# LAND CRUISER Station Wagon

## OUTLINE OF NEW FEATURES

The following changes are made for the 2010 model year.

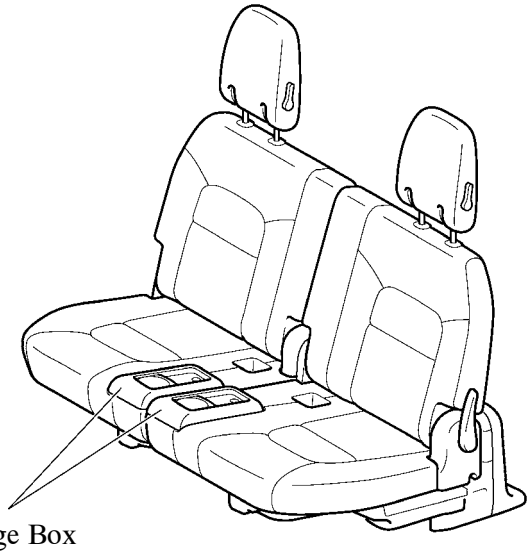
## 3. Brake Control System

The CRAWL operation conditions have been changed. For details, see page 7.

## 6. Steering Pad Switch

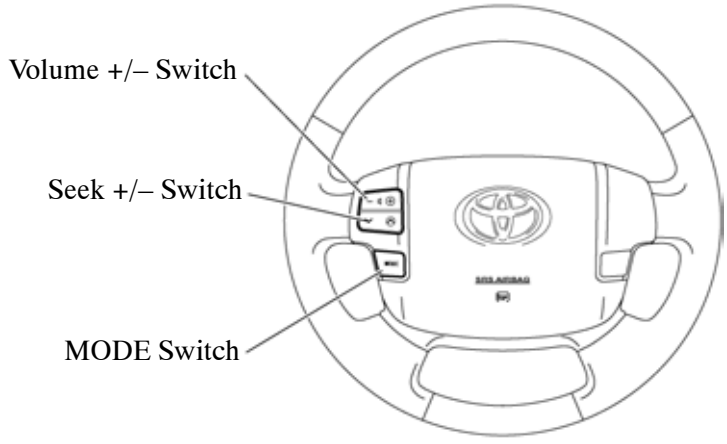
The steering pad switch has been provided as an option on the GX grade vehicle to improve the quality of the vehicle.

## 7. Power Outlets

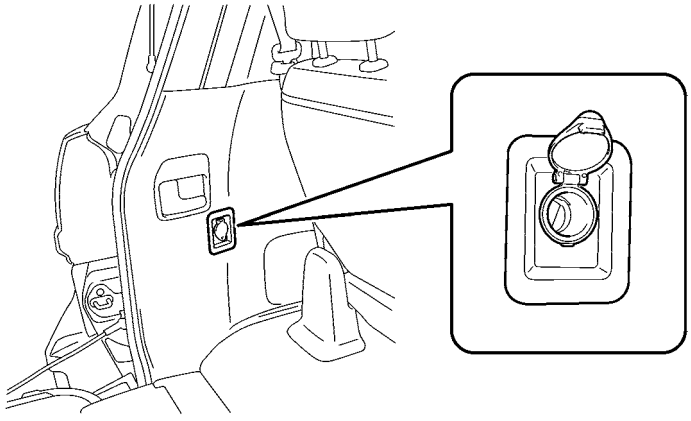
A power plug (12V/120W) has been provided on the left side of the rear cargo room.
